INVITATION TO TENDER NO. PS20200336
CONTRACTOR FOR RAYCAM COMMUNITY CENTRE PLAYGROUND REPLACEMENT

ADDENDUM NO.3

RE: REVISED DRAWINGS (Please refer to them as the most current version)

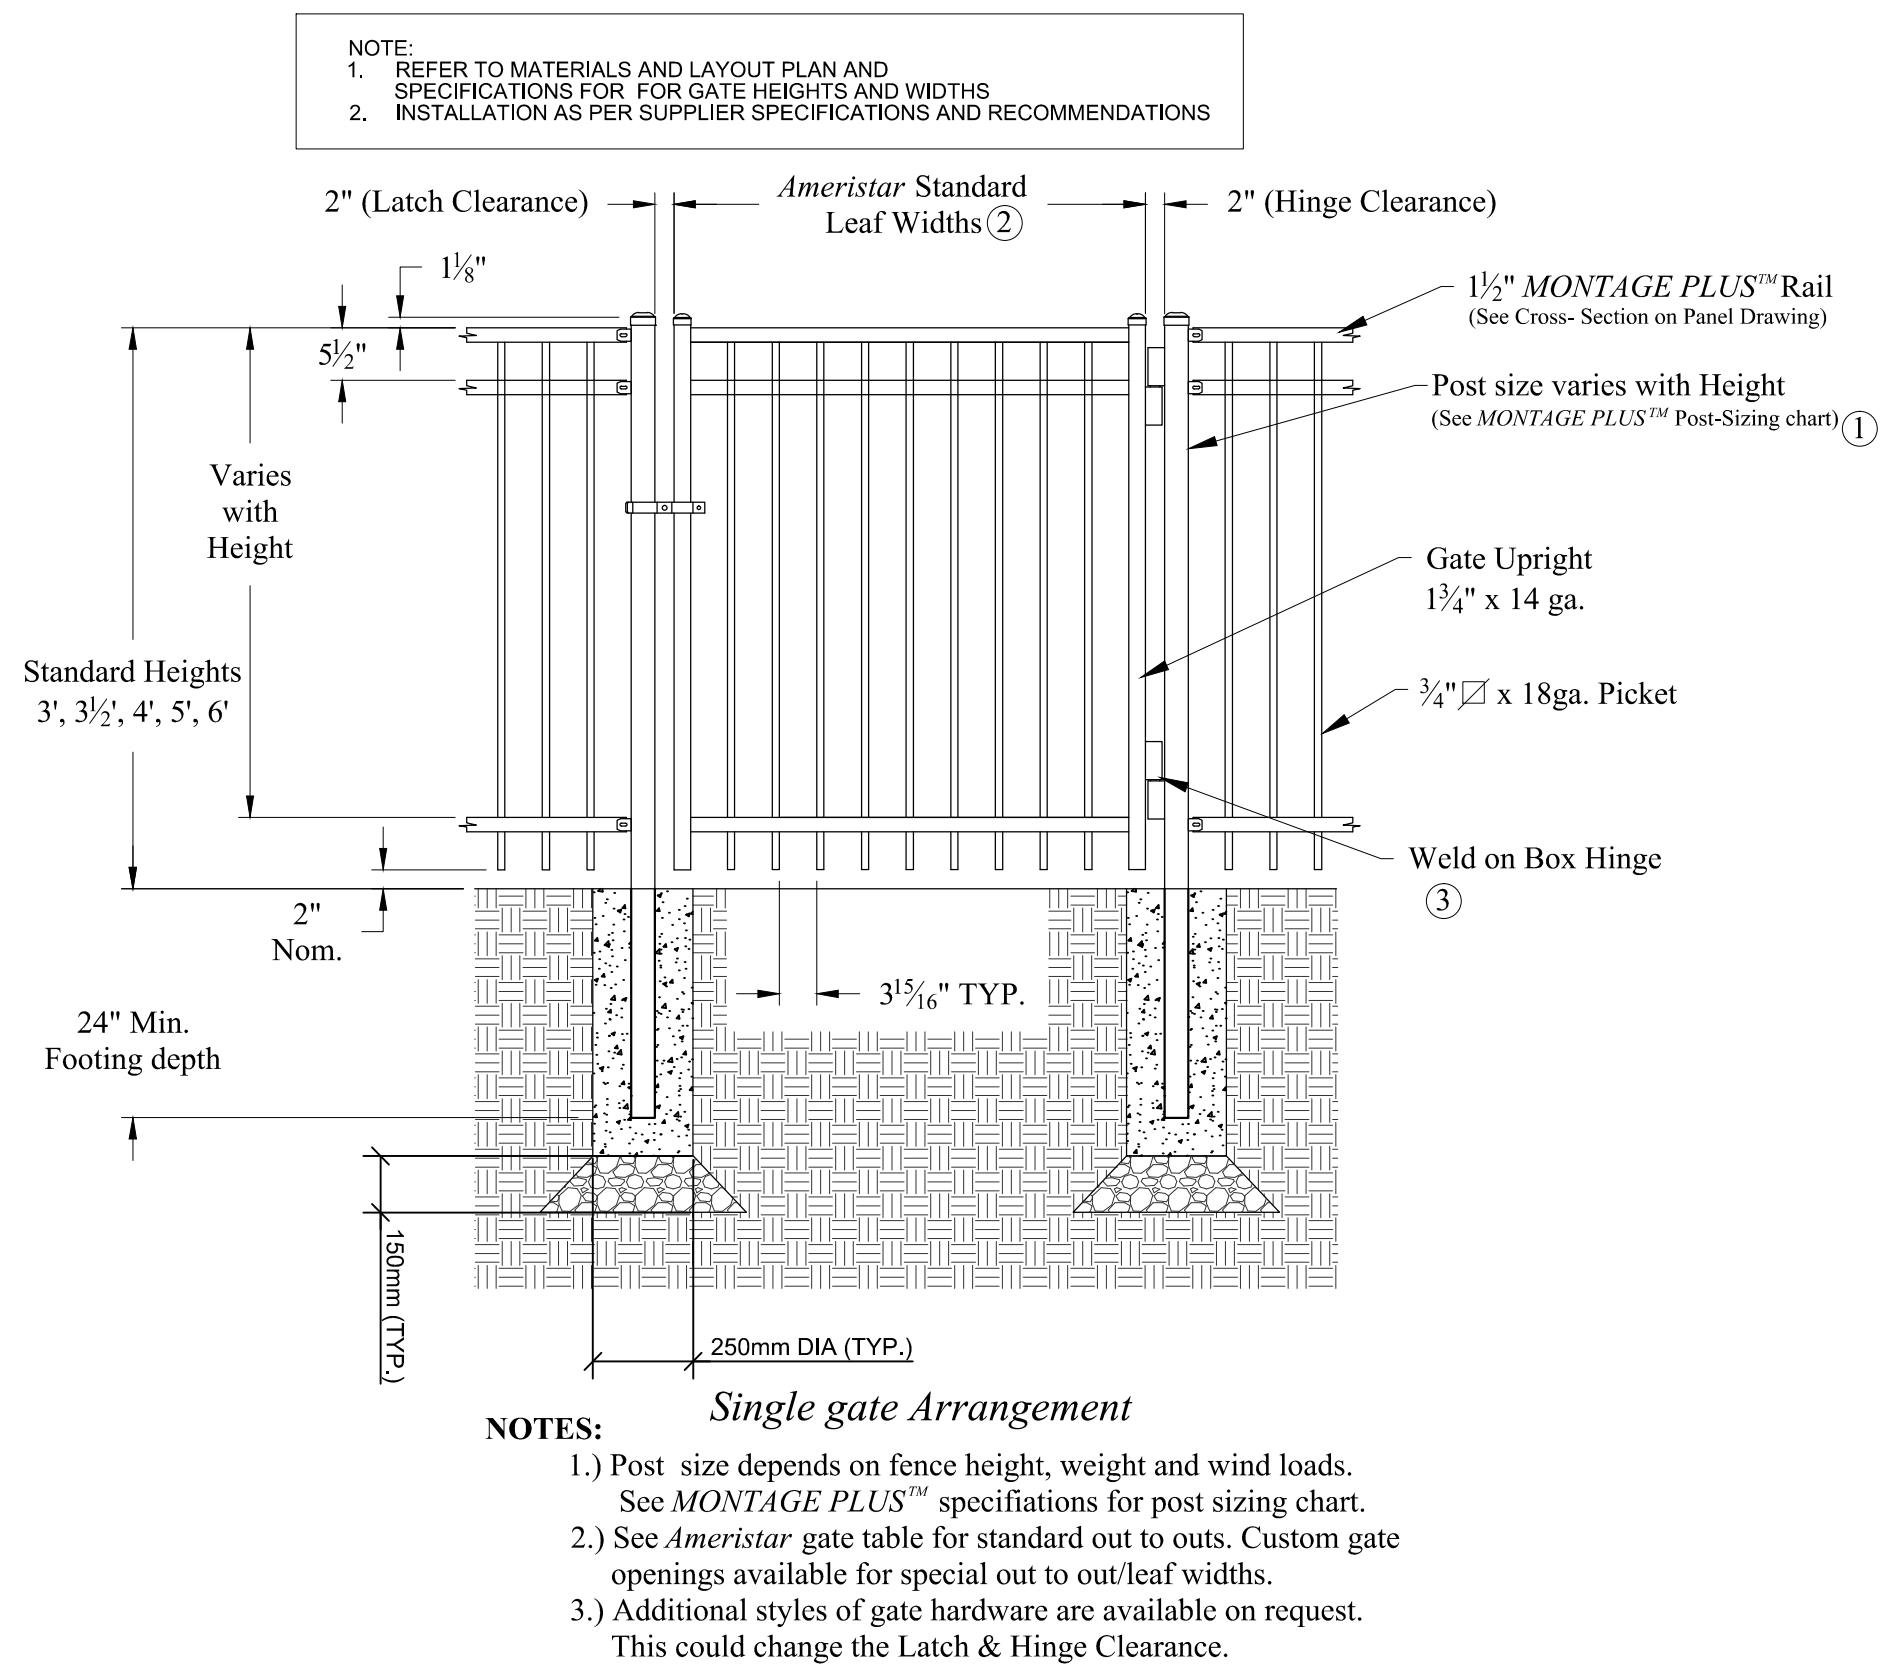
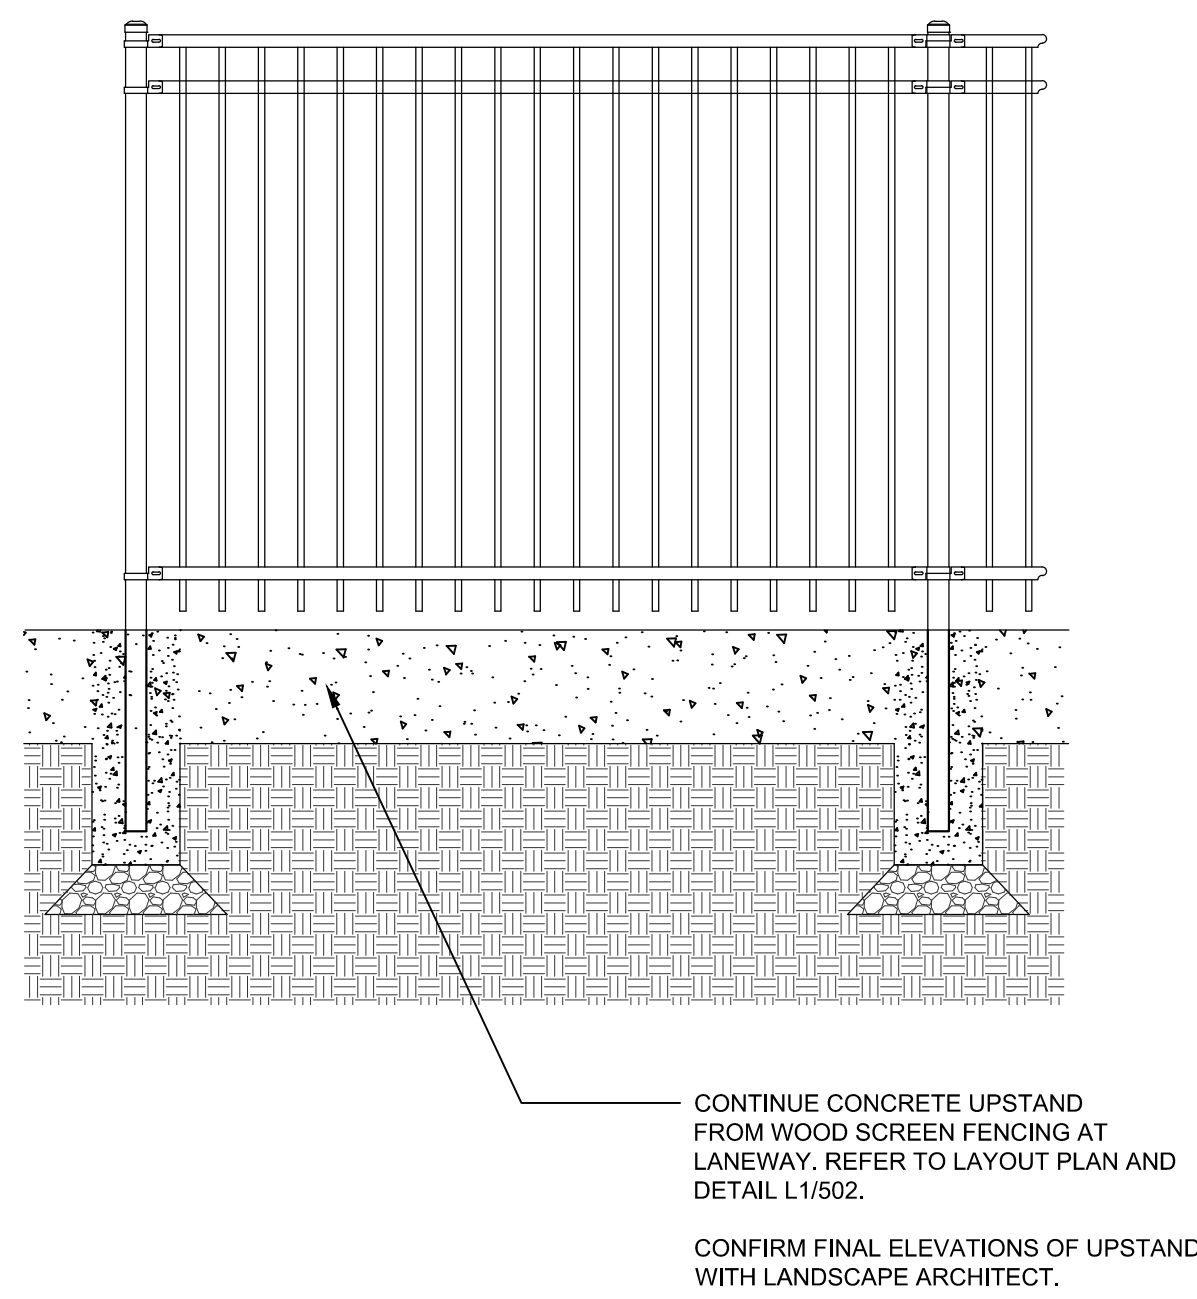
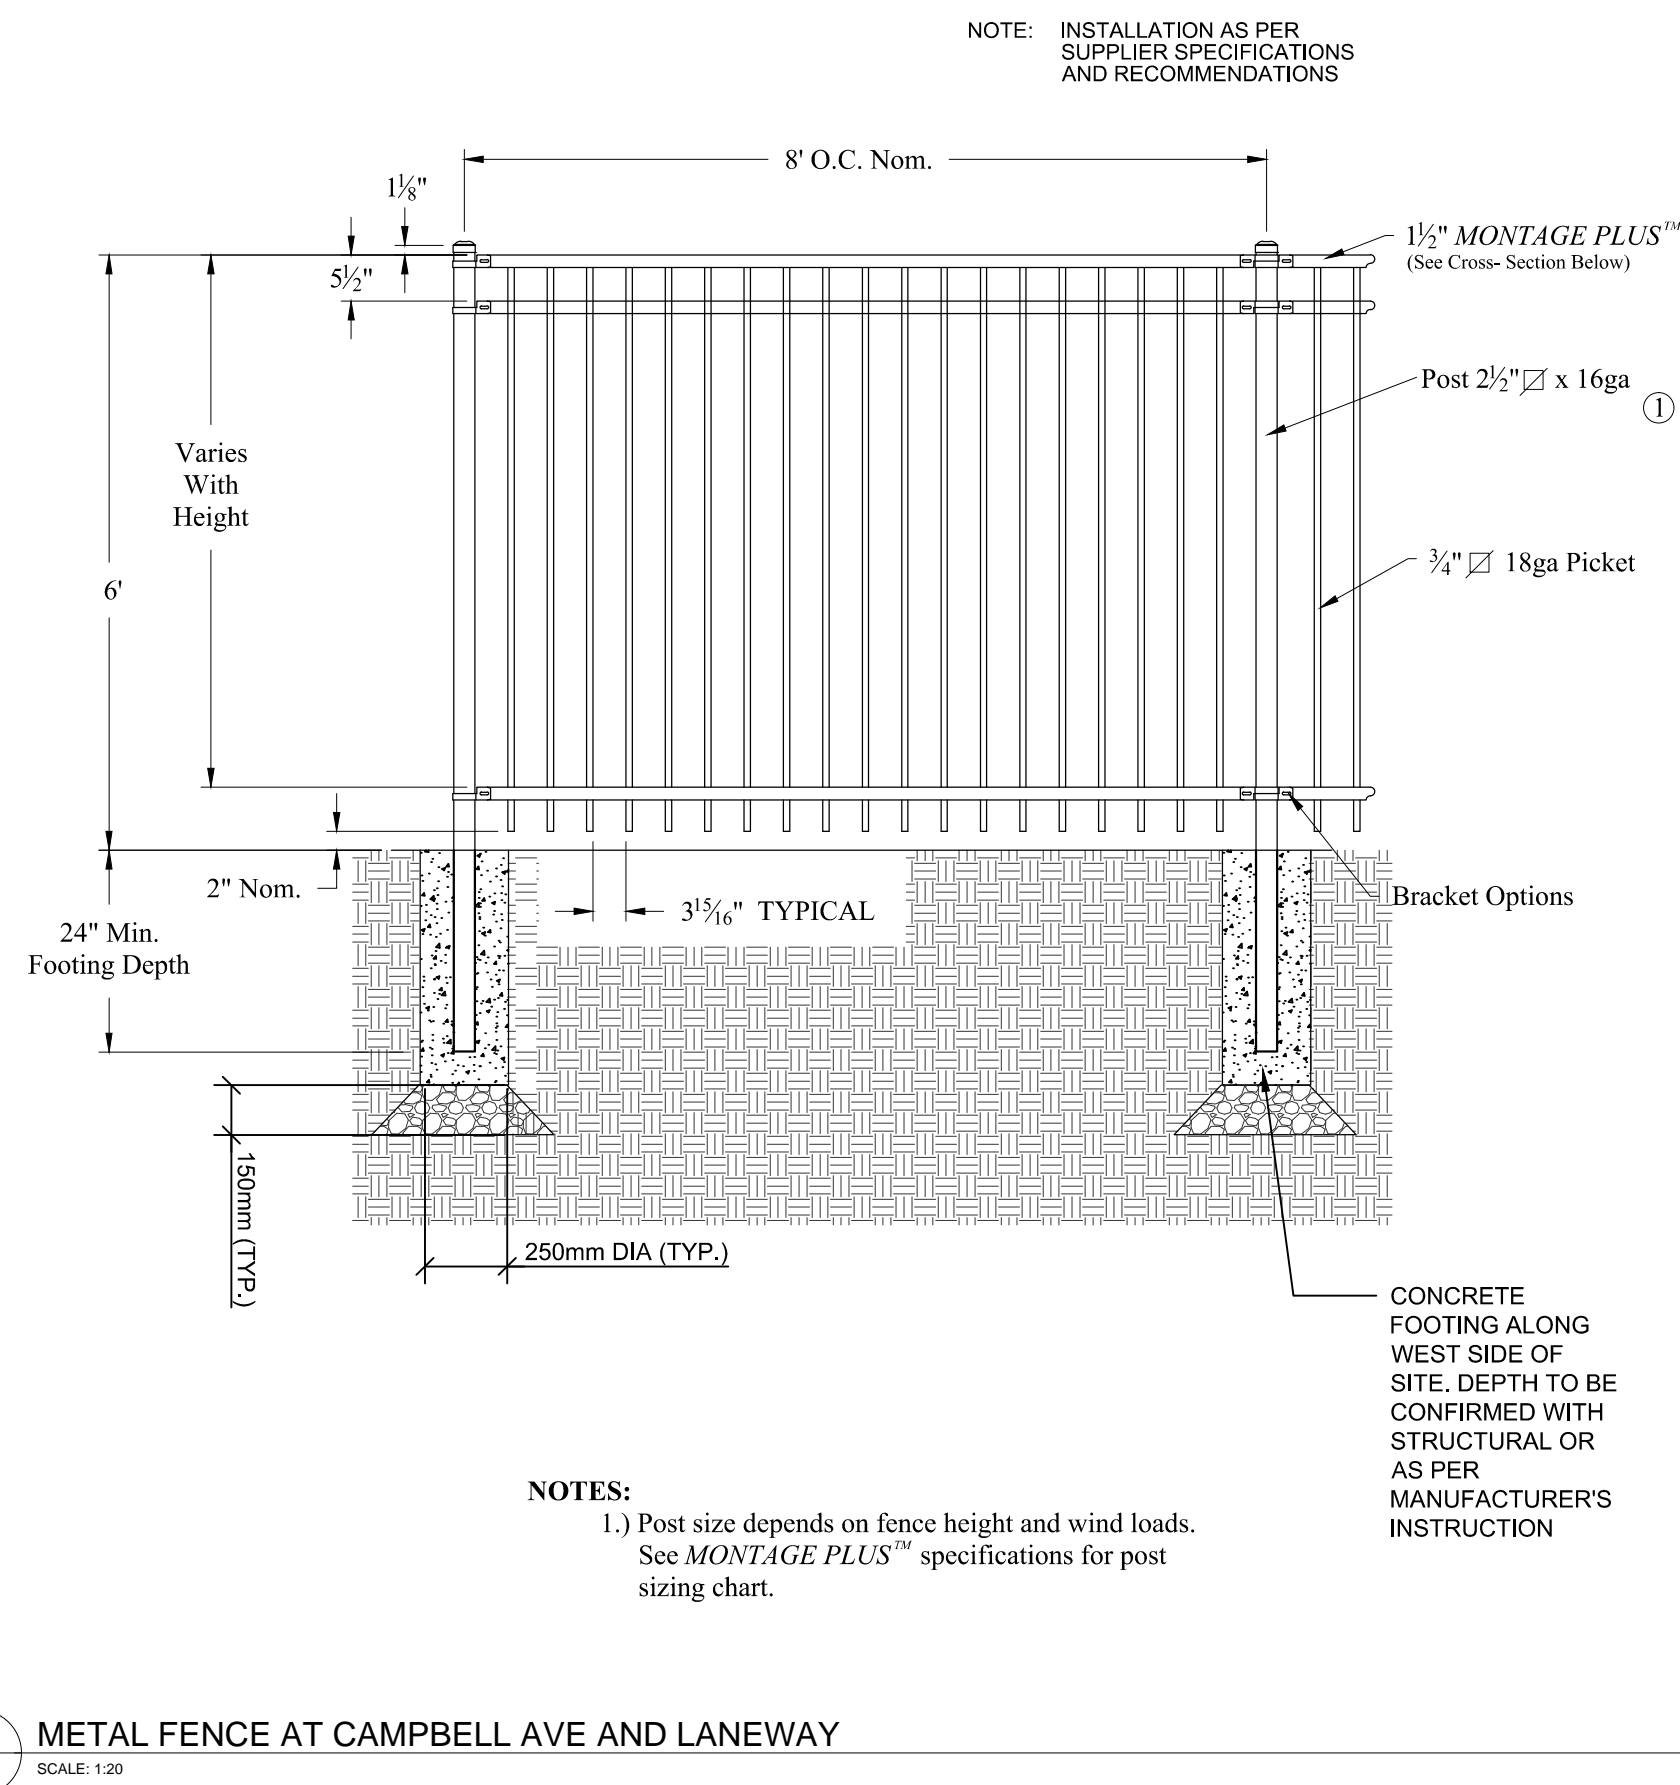
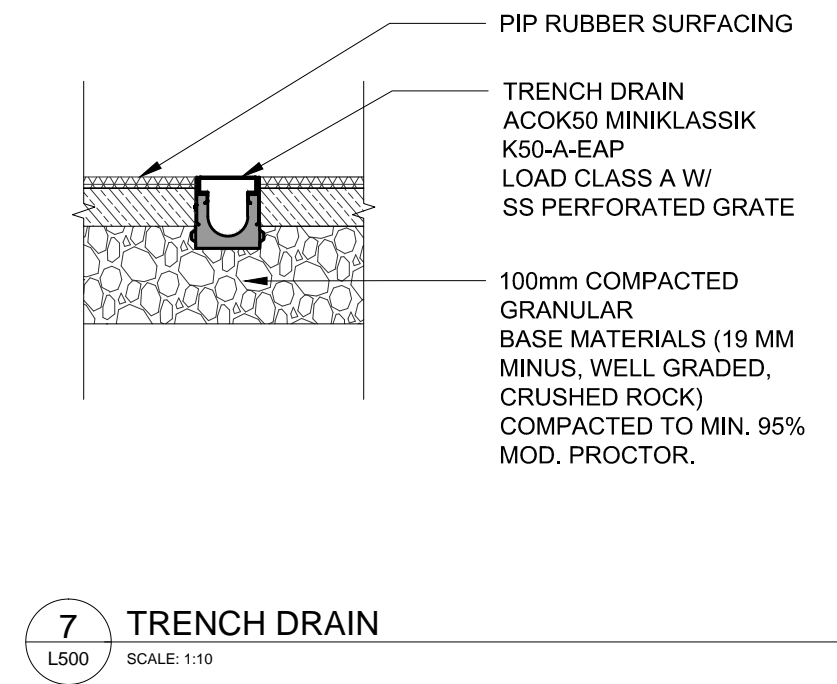
- L-500:
 - Revised detail 2/500: Deleted concrete curb. Shows rubber surfacing against the concrete upstand (for custom wood screen)
 - Revised detail 3/500: Deleted concrete curb. Shows the wood edger underneath the synthetic turf. Transition of turf and rubber surfacing to be seamless.
- L-200:
 - Previous M3 key revised to M4 with a clarified description and detail
- L-203:
 - New drawing separating the lighting as requested. This addendum must be completed, and attached to your Application form.
